CALL NO. 108
CONTRACT ID NO. 141233
ADDENDUM # 1

Subject: Christian County, STP 3017 (025)
Letting June 27, 2014

- (1) Revised - Plan Sheet - R2, R2A, R2D
- (2) Revised - Bid Items - Pages 200-203 of 203

TYPICAL SECTIONS

COUNTY OF	ITEM NO.	SHEET NO.
CHRISTIAN	2-8505.00	R2

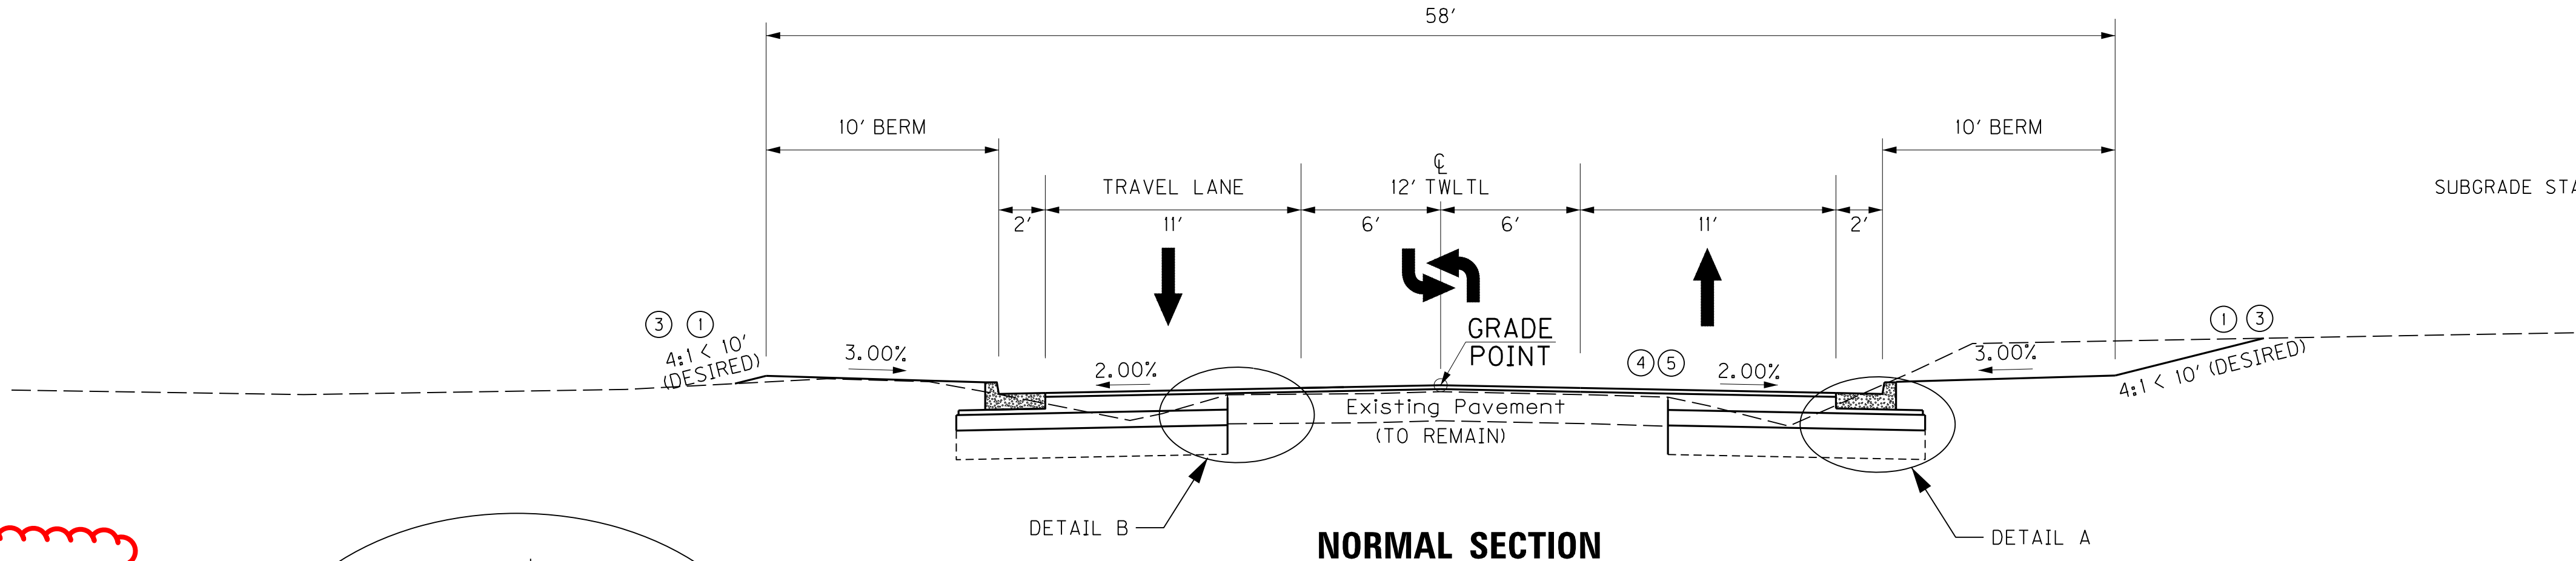
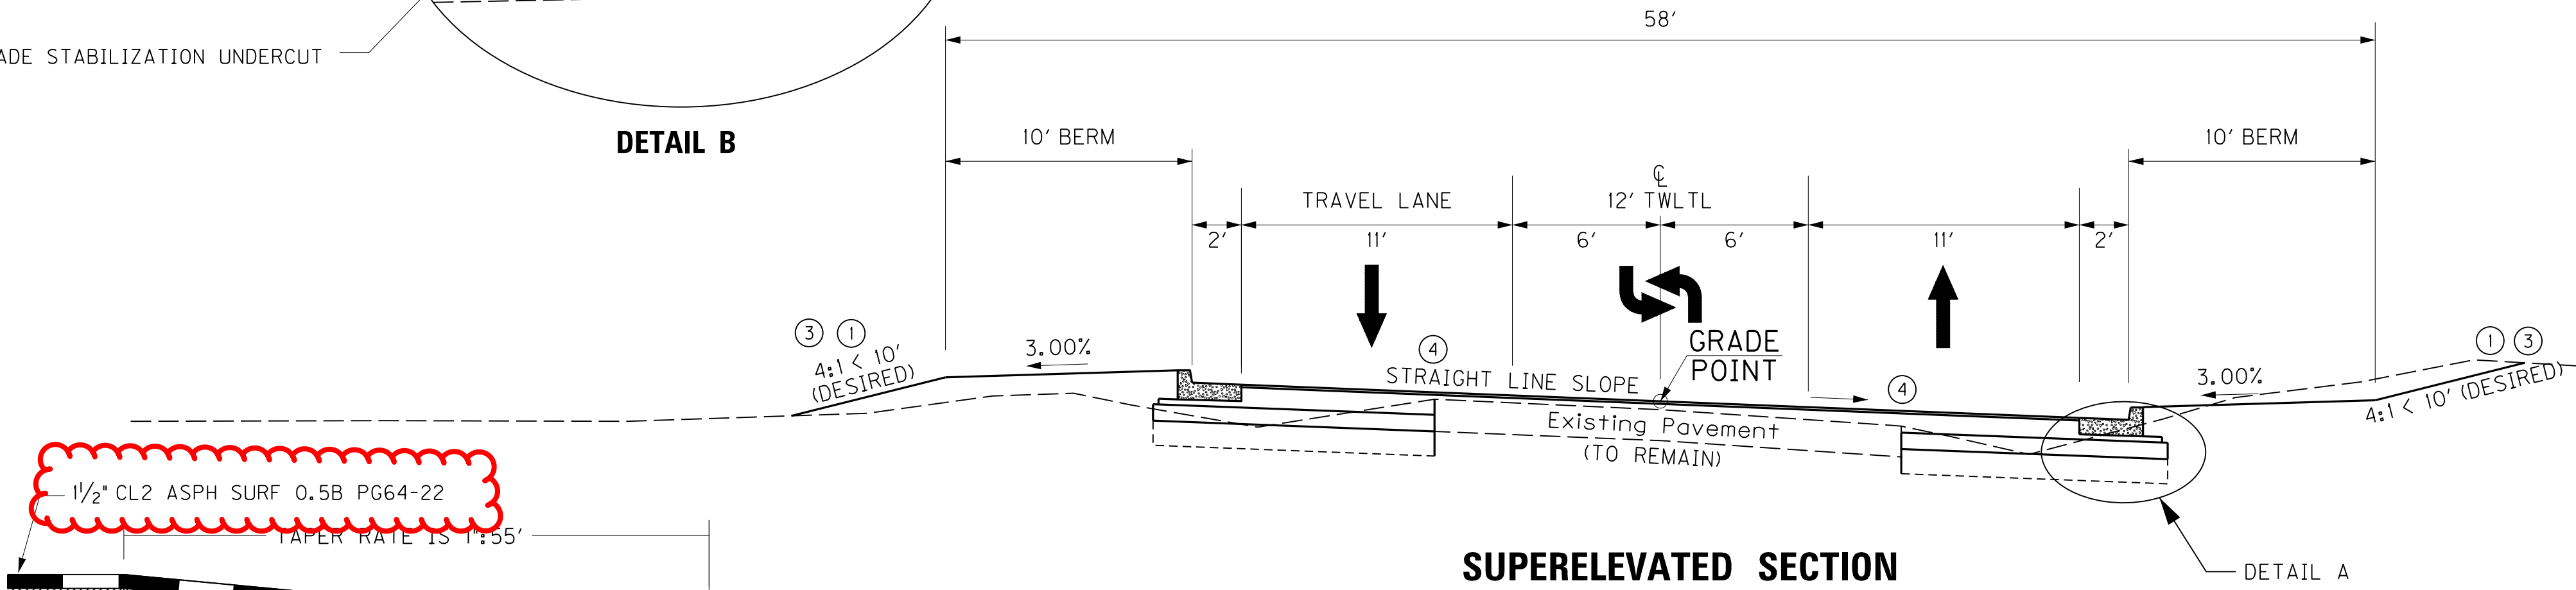
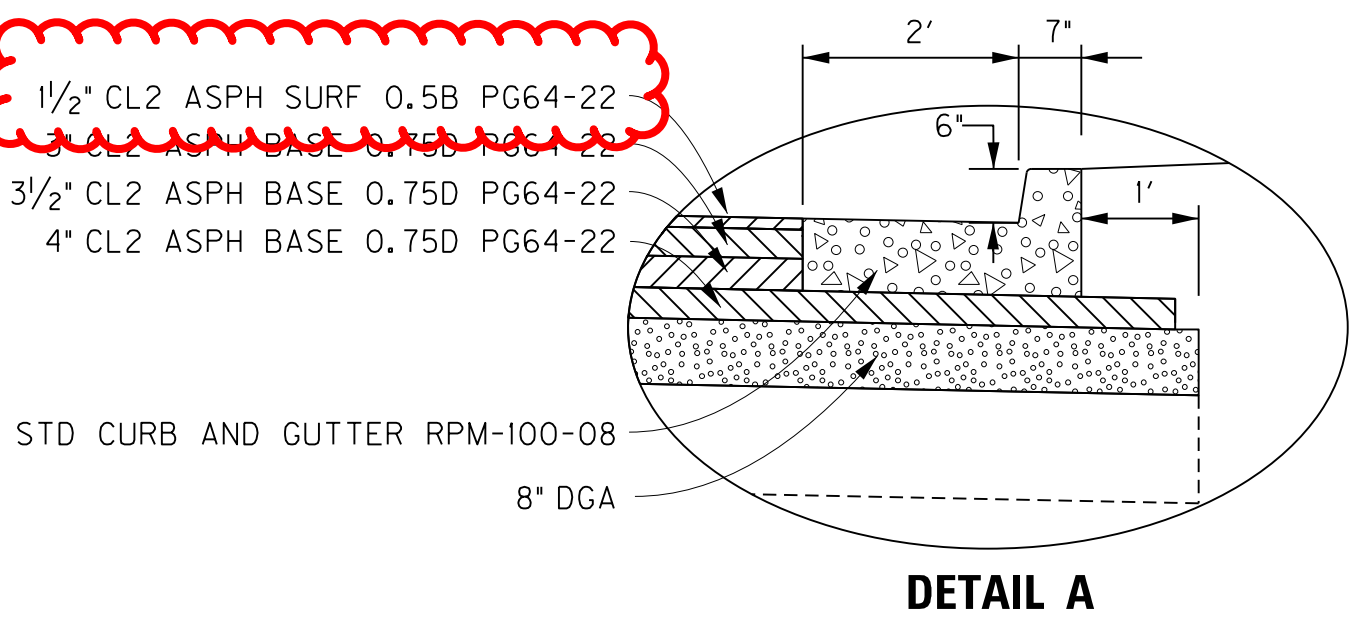
ASPH SURFACE WAS REVISED FROM 0.38B TO 0.5B AGGREGATE, AND ITEM NUMBER CHANGED ACCORDINGLY. ALL REFERENCES HAVE BEEN REVISED.

23362ES403	CL2 ASPH SURF 0.5B PG64-22	1/2" DEPTH
221	CL2 ASPH BASE 0.75D PG64-22	6 1/2" DEPTH (3' + 3 1/2')
1	DGA	8" DEPTH
